REVISED RESPONSE TO REQUEST FOR ADDITIONAL INFORMATION**APR1400 Design Certification****Korea Electric Power Corporation / Korea Hydro & Nuclear Power Co., LTD****Docket No. 52-046**

RAI No.: 114-8041
SRP Section: 03.04.01 – Internal Flood Protection for Onsite Equipment Failures
Application Section: 3.4.1
Date of RAI Issue: 07/27/2015

Question No. 03.04.01-3

Figure 3 Flow Opening Schematic drawing on El. 100 ft

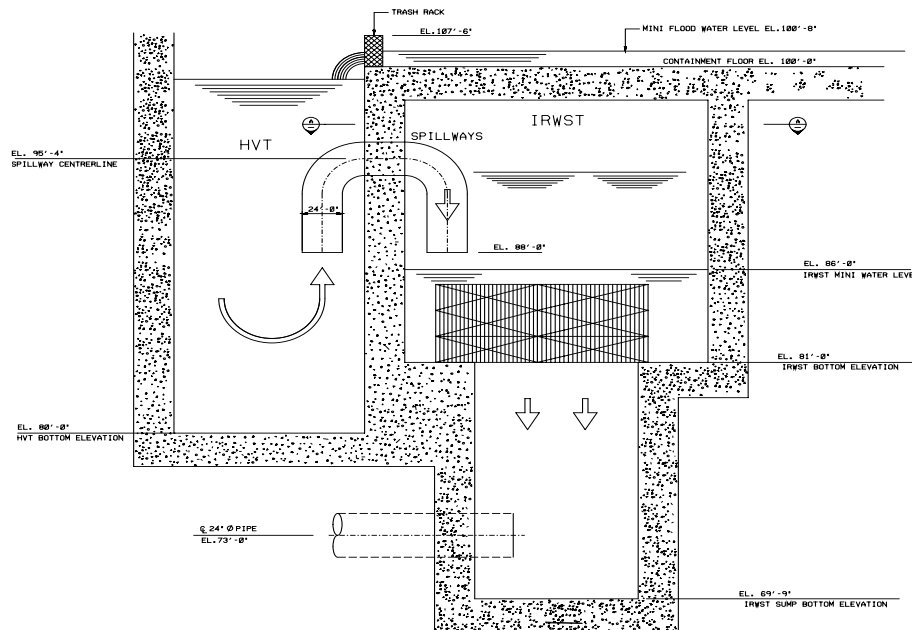
DCD Tier 2, Sections 3.4.1.3 and 3.4.1.5 identify the in-containment flooding sources as coming from a loss of coolant accident (LOCA) or from a break in the fire protection system. The applicant states that the worst-case flooding event is a double-ended discharge leg LOCA with the minimum safety injection because it results in the most limiting flooding source for the reactor containment building.

The applicant is requested to provide the following information relating to the determination of the worst case:

- a) Provide a comprehensive explanation of the calculation method for using “maximum break”, instead of “maximum flood water volume” to determine the worst case flooding event. In general, flood level is determined by the water volume. Provide design requirements (such as the drain capability) and the basis to support the method being used by APR1400.

- b) Explain the basis for the determination of the worst case being LOCA with duration of 50 second. It should be noted that LOCA has higher peak flow but drops quickly lasting much longer than 50 second, while fire protection water could leak indefinitely without isolation resulting in larger volume of flood water. If isolation is used, provide the design basis and justifications.

- c) Explain how other in-containment water sources (such as main feedwater line, main steam line, auxiliary feedwater system, shutdown cooling system, component cooling system, safety injection tank (SIT), and other water carrying piping) compare against the worst case LOCA?

The flowrate through the opening is generally calculated by using the weir equations as depicted in Table 2 below. The shape of floor openings at EL.100 ft is similar to the sharp-crested rectangular and broad-crested rectangular weirs from Figures 1 through 3; thus, the associated equations are appropriate to use to calculate the flow rate in APR1400 DC.

The swirling effect is considered negligible since the floor opening width is sufficiently large and the flood source due to a FW line break would flow to EL.136 ft, down to EL.114 ft and finally to EL.100 ft of the containment building through gratings or stairwells. Thus, the flow rate will be decreasing such that the swirling effect is not significant.

- Flow into the HVT opening at EL. 100 ft. is calculated by the sharp-crested rectangular weir equation and flow into the IRWST (through the spillway) is calculated by the pressure drop equation, Darcy's formula.
- Flood source is a FW line break flow (190 ft³/sec) with AFW makeup flow (1.97 ft³/sec).
- Sharp-crested weir equation: $Q = \frac{2}{3} C_D \sqrt{2g} B H^{3/2}$

The discharge coefficient (C_D) used is 0.60 and the blockage of the opening by trash rack is additionally considered to be 38% (0.62) for conservatism. The width of the weir (B) is 25.1 ft.
